PRELIMINARY OVERALL AREA DEVELOPMENT PLAN
MEDINA VALLEY RANCH SUBDIVISION
BEXAR COUNTY, TEXAS

Re: Medina Valley Ranch

POADP # 618

P.O.A.D.P. REVIEW

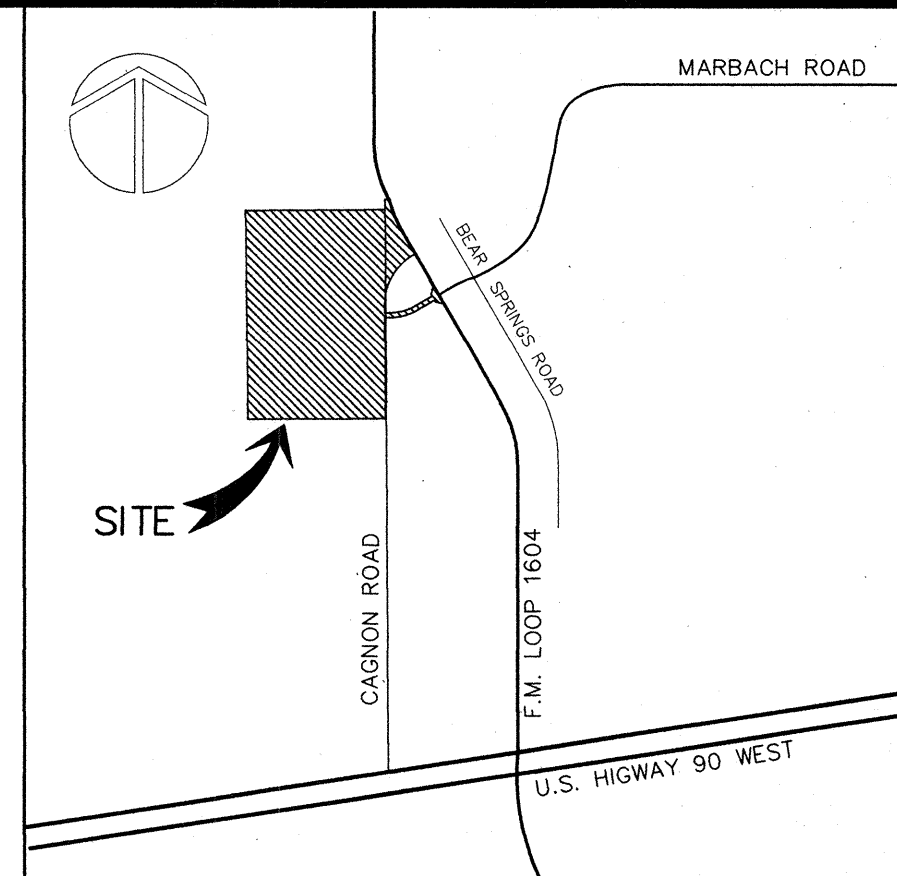
The City Staff Development Review Committee has reviewed Medina Valley Ranch Subdivision Preliminary Overall Area Development Plan # 618. Please find enclosed a signed copy for your files. Although your plan was accepted, please note the following:

- Based on the topography, a Flood Plain Study and drainage review will probably be required during the platting process.
- In consideration of public safety and convenience, excessive grades by reason of topography should be avoided in street layouts and arrangements.
- Access and R.O.W. issues along State facilities will need to be resolved with the Texas Department of Transportation (TXDOT). For information about these requirements you can contact TXDOT at 615-5814.
- This development will need to comply with tree preservation ordinance #85262. For information about these requirements you can contact Building Inspections at 207-7102.
- It will be expected that you will plat all of the property depicted in your POADP, to include: floodpains, drainage areas and open space.
- I would encourage you to work closely with the school district, so that they can plan accordingly.

For residential development directly adjacent to State ROW, the developer shall be responsible for adequate set-back and/or sound abatement.

Variable Width Row dedication along Loop 1604.

This property is eligible for a maximum combined total of one(1) access point located at the extension of Marbach Road. Locations will be as directed by "Regulations For Access Driveways to State Highways".

- TIA
- Trees
- TXDOT
- drainage
- 1' non access easement
- Show collector + local B road curb cuts from streets
- Slope note

• show ROW
4 cagnon

- TIA
- Trees
- need 1' non access easement
- What does shading mean.
- label Street
- How is unit 4 = lot 4 and where is the Street frontage.
